Product Update Memo

INDUCTIVE COMPONENTS

Data Sheet Correction to Solder Terminal Dimension for SRP1265(A) Shielded Power Inductor Series

Figure 1

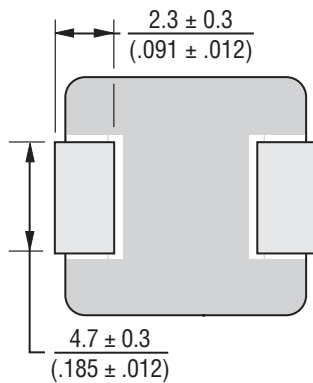
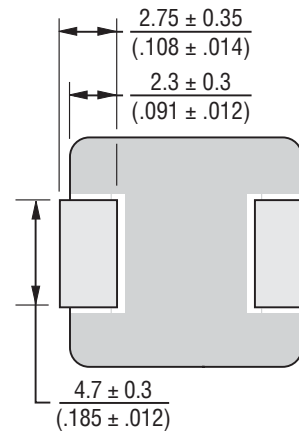
Recently, an error has been discovered in the solder terminal dimension of the [Model SRP1265\(A\)](#) data sheet drawings. The erroneous dimension (*Figure 1*) has been corrected (*Figure 2*).

The solder terminals of these two series have been manufactured to the *Figure 2* dimension since the inception of these inductors. This data sheet correction for Model SRP1265(A) has no impact to the form, fit, function and quality of the components.
